RE: Crown Castle/Verizon Wireless at 423 San Pablo Avenue

At the direction of the City of Albany, I have reviewed the current project documents and documentation for Crown Castle's proposal to modify its existing site, referenced above, on behalf of its client, Verizon Wireless.

**Figure 2.** Photograph of the Project Site Pole, Antenna Arrays, and Coaxial Cables. Photograph by J. Kramer.

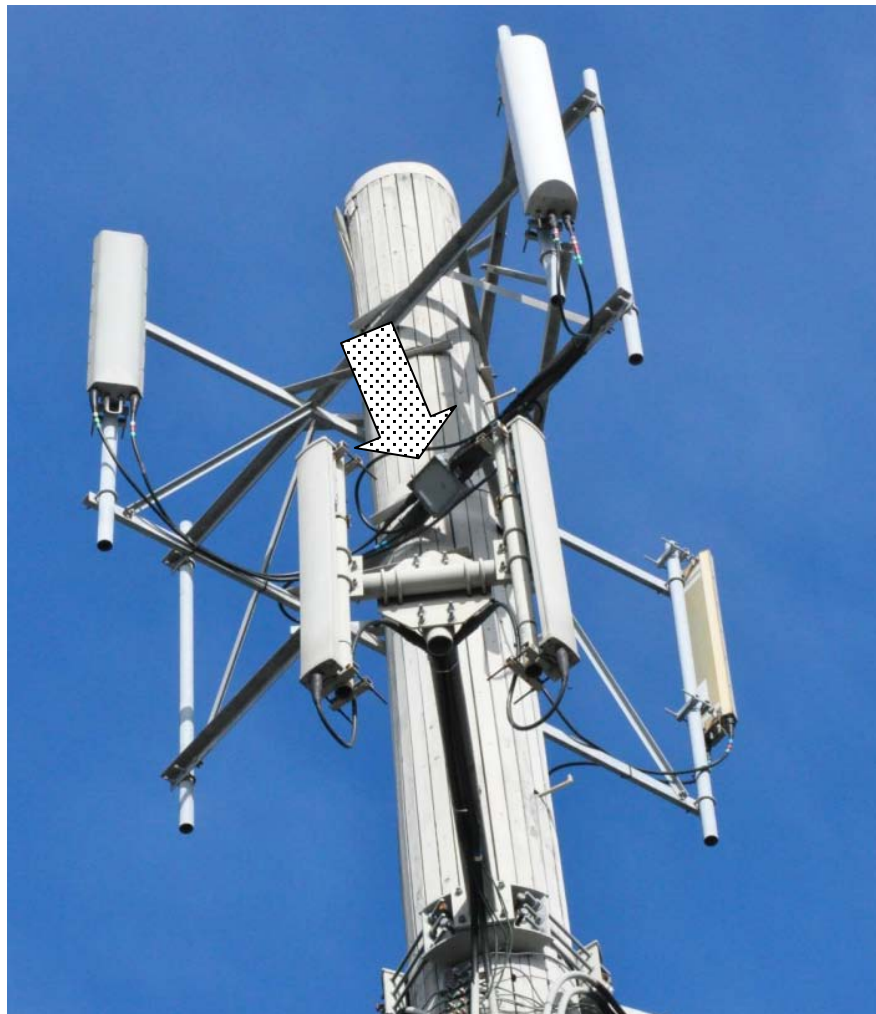
Figure 2 highlights several important issues regarding the current site and proposed project. First, the current Project Plans do not show where the

proposed eight (8) new coaxial cables will run. Given that the MetroPCS cables had to be installed on the face of the wood pole, and lacking disclosure about the coaxial cable location for Verizon's new antennas, it is possible that those cables will also have to be located on the face of the pole. Adding a substantial number of new cables to the face of the pole will substantially alter the visual impact of the current project in a negative manner. Figure 1 also serves to illustrate that the antenna cables are quite visible, but not represented in the Project Plans.

**Figure 3.** Close-up photograph of the Project Site Antenna Arrays (Verizon on top).

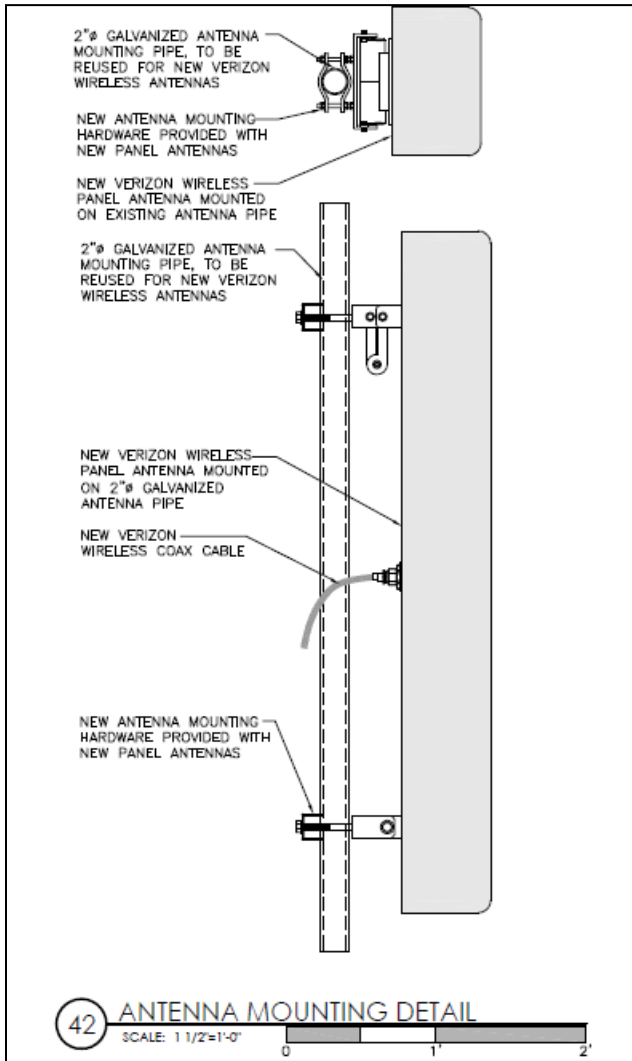
The white arrow in Figure 3 points to Verizon wireless equipment that is not shown in the current plans. This equipment was also not shown in the 2009 Plans. The current Project Plans under-represent the amount of

equipment which Verizon has currently installed on the pole. They also under-represent the amount of cables and other non-antenna equipment that is likely to be installed in connection with the proposed project given that it is quite common for large elements such as "tower mounted amplifiers" to be installed adjacent to antennas.

Figure 6. Ground elevation change along San Pablo Avenue from El Cerrito to Berkeley.

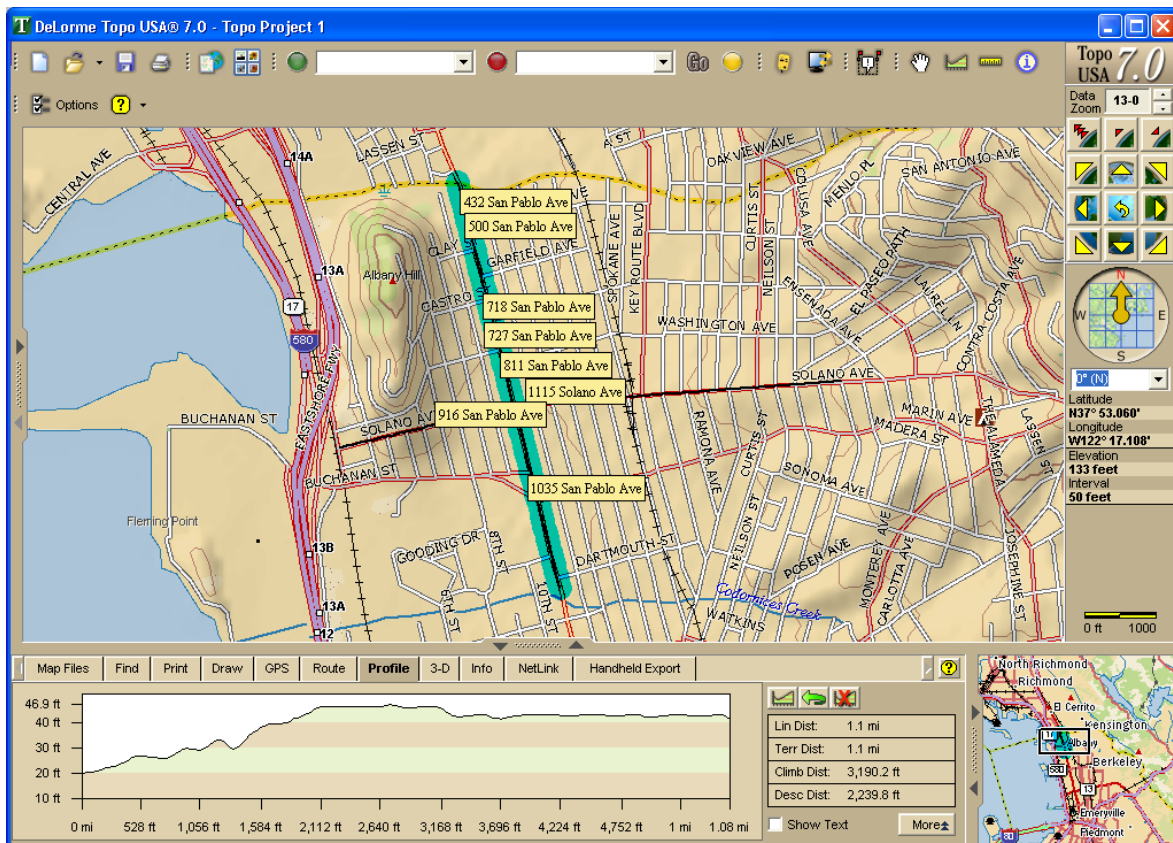
More to the point, however, is that Verizon is asserting that it can utilize a coverage study prepared for the 423 San Pablo site, and apply it wholesale to all of the alternative sites without performing individual studies for each alternative site. This is simply incorrect from an engineering perspective, and ignores changes in topography between the various alternative sites. This is highlighted in Figure 6, below.

Figure 6 is a screen capture from a commercial topographic program using U.S. Geological Survey base map data. It shows that an elevation change of nearly 27 feet occurs along the length of San Pablo Avenue where the bulk of the alternative sites are located. The ground elevation at the City's border with El Cerrito is approximately 19.8 feet above sea level, peaking at about 47 feet just south of Washington Avenue, and declining to about 41.5 feet at the Berkeley border.

Figure 7. Ground elevation change along Solano Avenue from I-80 to Berkeley.

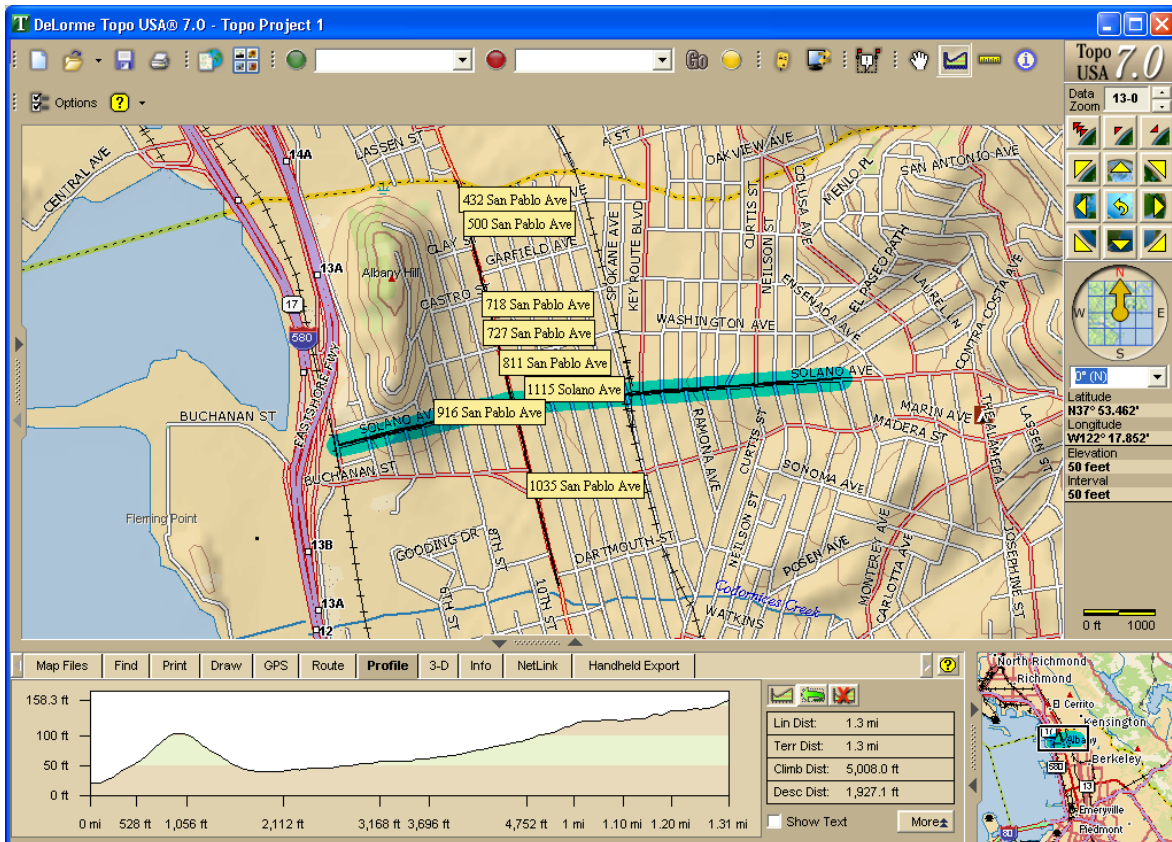
Figure 7 is a screen capture of from the same topographic program showing an elevation change of nearly 138 feet along Solano Avenue from I-80 to the Berkeley border. The ground elevation at the City's border with I-80 is approximately 18.8 feet above sea level, rising in the area of the Albany Hill to about 103.5 feet, then dipping to about 46 feet at the intersection with San Pablo Avenue, and finally increasing to a ground level height of about 156.5 feet at the Berkeley border.

The three-dimensional ground elevation changes just discussed are significant from a wireless signal coverage perspective as they directly impact signal propagation characteristics. These significant ground elevation changes should have been considered by Verizon, but were not, when it explored the alternative sites it put forward to the City.
